**TECHNICAL REVIEW COMMENT SHEET
Salt Waste Disposal**

| UNITED STATES DEPARTMENT OF ENERGY SAVANNAH RIVER SITE | | Document Review Record SRR-CWDA-2009-00010 | |
| Document No./Title: SRNS-STI-2008-00050, Evaluation of Sulfate Attack on Saltstone Vault Concrete and Saltstone, Part I: Final Report | | Rev. No.: 0 | Doc. Date: 8/19/08 |
| Reference: 3/25/09 – 3/26/09 NRC Onsite Observation Report for Saltstone (NRC Document No. ML091320439) | | | |

ML091320439
#20 (Cont'd)

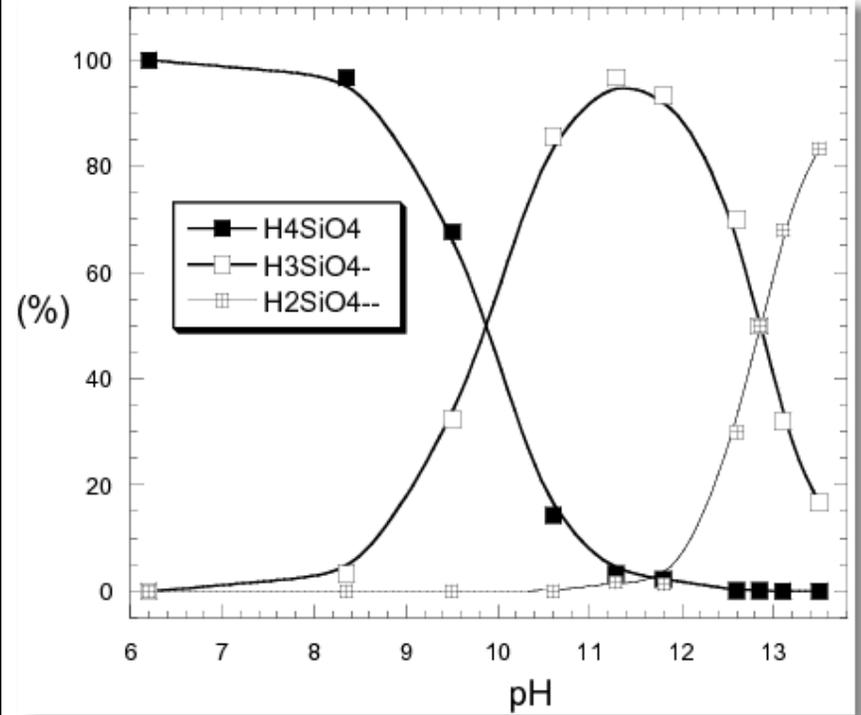
| UNITED STATES DEPARTMENT OF ENERGY SAVANNAH RIVER SITE | | Document Review Record SRR-CWDA-2009-00010 | |
|--|---|--|--------------------|
| ML091320439 #20 | Explain why it is appropriate to neglect minor species (page A2-14). | <p>Minor species are not expected to significantly influence sulfate attack in particular and the evolution of the concrete matrix in general. SRS does not have direct access to the STADIUM, proprietary software of SIMCO Technologies. However, after consultation with SIMCO, minor species are addressed as follows:</p> <p><i>Components such as calcium or silica, when dissolved in solution, form different species. In the case of silica, species such as H₂SiO₄²⁻, H₃SiO₄¹⁻ and H₄SiO₄⁰ are present in solution. The relative proportions of these species depends mainly on the pH of the solution. As illustrated in the figure below, some species are dominant in low pH conditions and become negligible at high pH. Cementitious materials contain a high pH pore solution. Accordingly, the species selected for the calculations corresponds to the species showing the highest concentration at high pH. Referring to the figure, H₂SiO₄²⁻ was selected over H₃SiO₄¹⁻ and H₄SiO₄⁰. Similarly, Ca²⁺ was favored over CaOH⁺ in the case of calcium. Once the main species are selected, the dissolution/precipitation reactions of the minerals considered in the calculations are expressed as a function of those species.</i></p> | |
